ISSUE: Certificate of Appropriateness for alterations

LOCATION: Old and Historic Alexandria District
201 Gibbon Street

Staff recommends denial of the Certificate of Appropriateness for the replacement of the existing windows.

**BAR#2024-00038**
201 Gibbon Street

Figure 1: Proposed modifications to 201 Gibbon Street

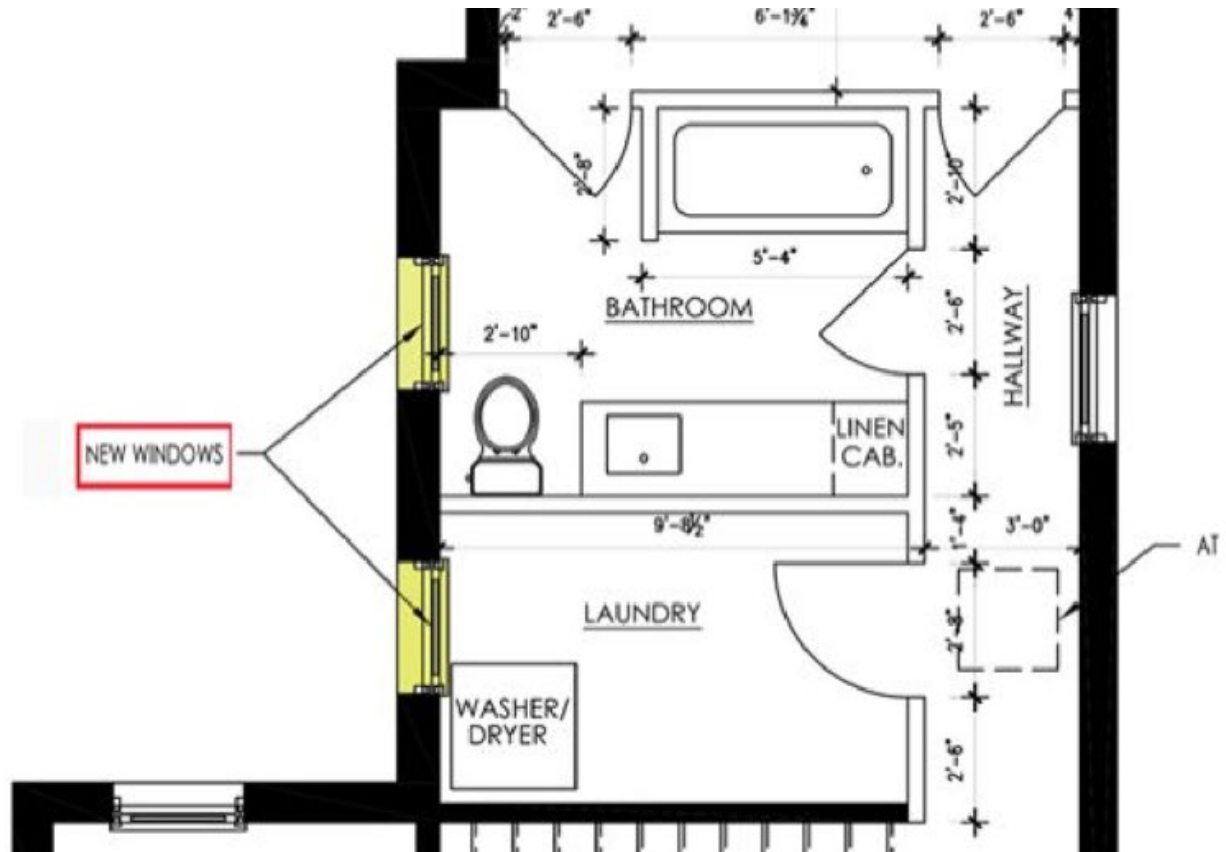
The applicant requests a Certificate of Appropriateness to replace two second floor windows (Figure 1); removal of chimney was previously approved.

While there are several mitigating factors in the proposed replacement of the two second floor windows on the south elevation of 201 Gibbon Street, the Design Guidelines clearly indicate that historic windows should be retained and repaired wherever possible. To be consistent with these Guidelines, staff recommends the denial of a Certificate of Appropriateness for their replacement.

Figure 2: Photograph from 1883 showing property viewed from the waterfront.

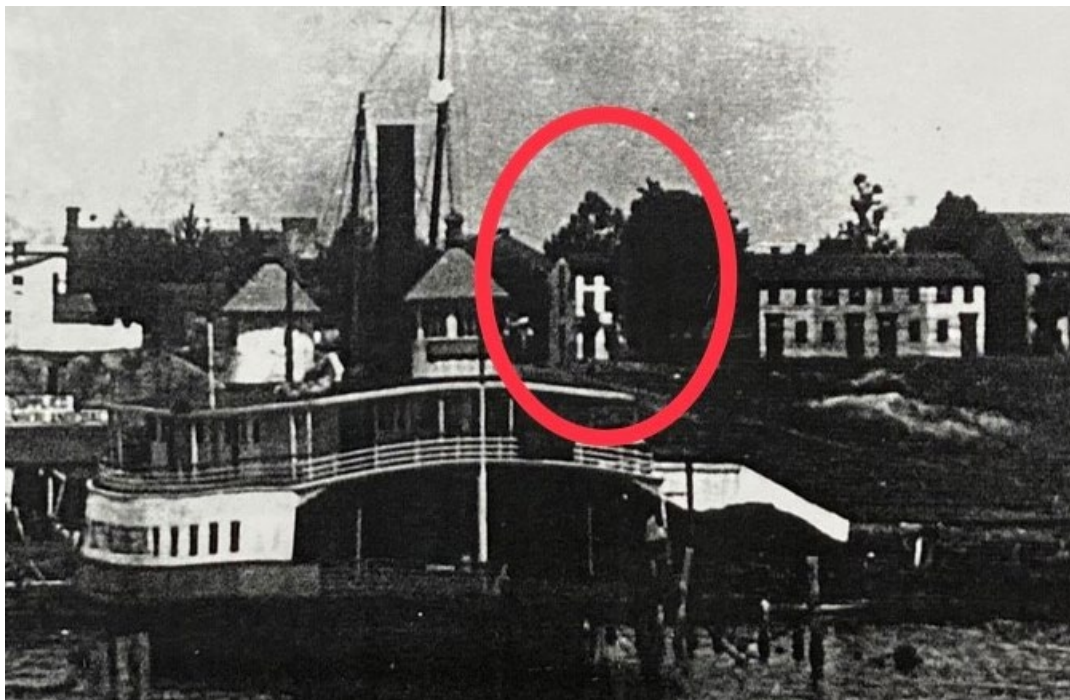
The structure at 201 Gibbon Street dates from the middle of the 19th century and is therefore considered to be an Early building. The structure appears on the 1877 Hopkins Map. According to Ethelyn Cox's *Historic Alexandria Virginia Street by Street*, the corner lot with the current boundaries was sold to Henry Baker in November 1863 and Mr. Baker was responsible for the construction of the home. This places the construction of the original portion of the property sometime **between 1863 and 1877**. The applicant has provided a photograph of the property dating from 1883 that appears to show the house as viewed from the Alexandria waterfront (Figure 2).

Figure 3: 1951 drawings showing the relocation of the subject windows from the western exterior wall

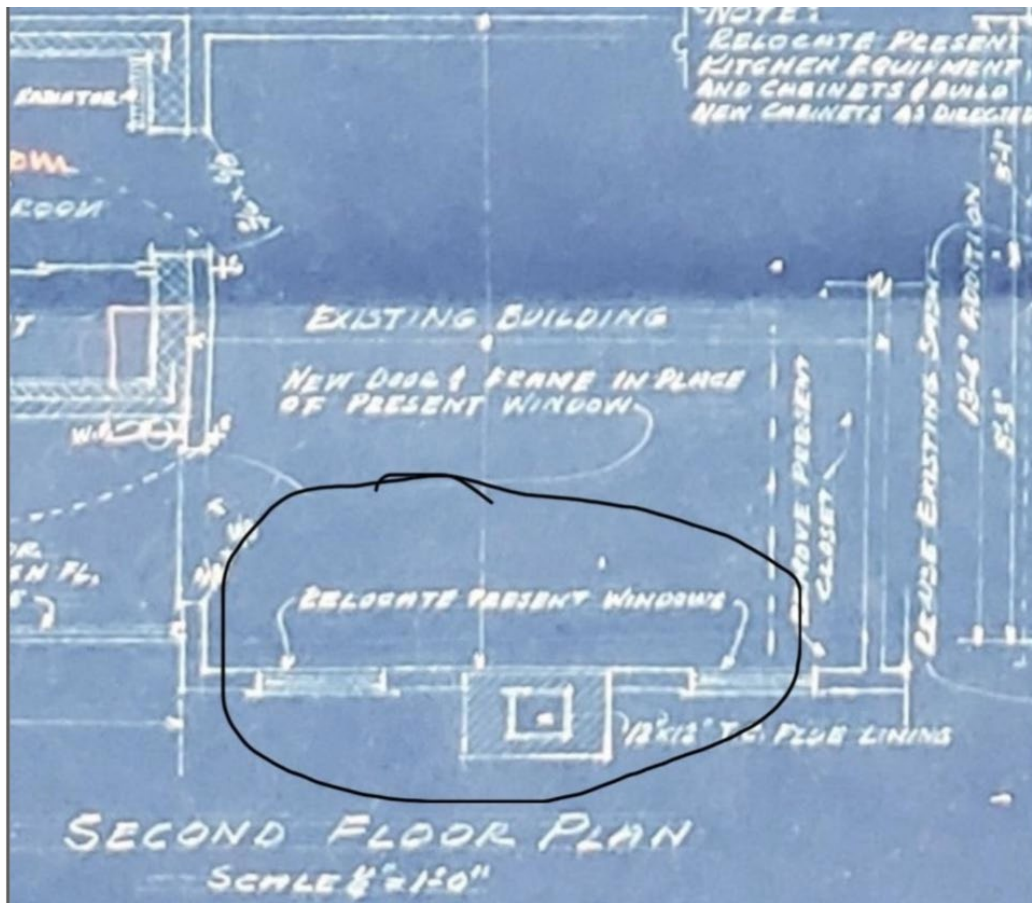
In 1951 the building underwent another addition, with a masonry wing added to the west side of the structure. The original blueprints from that addition show a new chimney being built on the southern exterior wall and include notes indicating that two windows located on the western exterior wall be relocated to the southern wall (Figure 3). In 1952, a memo was written to the City building inspector indicating that the location of the proposed chimney was to be changed to the interior of the building, not along the south wall.

This memo did not address the relocation of the windows, so it appears that the windows were relocated to their current location. Staff was able to observe the framing of the wall in this area from the inside of the structure because some of the interior finish has been removed. The wall framing in the area did not definitively indicate whether or not these windows had been relocated but the location of door openings in the adjacent western wall is consistent with the 1951 drawings. With these factors, it appears likely that the subject windows are not currently located in their original locations.

As noted above, the subject windows likely date from the turn of the century and have been heavily modified since their original construction. Construction drawings clearly demonstrate that these windows have been relocated as part of the construction of the western masonry addition. While these windows are old, they date from a later portion of the building and were subsequently modified in 1952.

Figure 5: 1941 Sanborn Fire Insurance Map with 1950-1951 modifications indicated

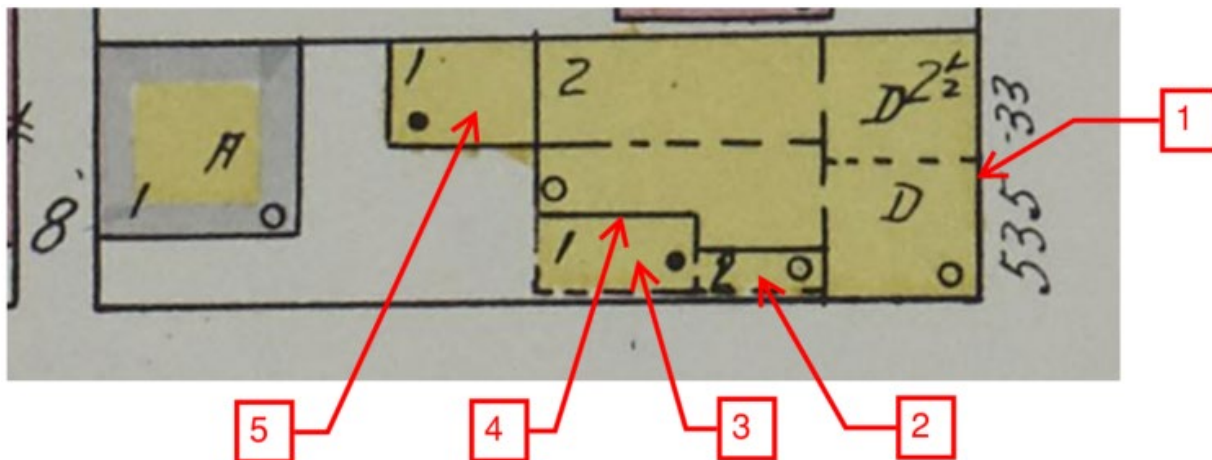
In addition to the history of the windows themselves, the applicant has researched the chronology of the house with a focus on the rear section of the structure where the subject windows are located. At some point between 1945 and 1949, the existing structure known as 201 Gibbon Street was created by combining two separate structures, 533 and 535 South Lee Street. In 1950 and 1951 two major renovations occurred on the now single dwelling. These changes heavily modified the rear section of the structure. Included in these changes were the following (Figure 5):

Between 1950 and 1952, the structure underwent substantial modifications including the combination of two buildings into the single residence that exists today and significant modifications to the south elevation. The subject windows are integral to this southern elevation and given the level of modifications to this area, the effective date of this portion of the building should be considered to be 1952.
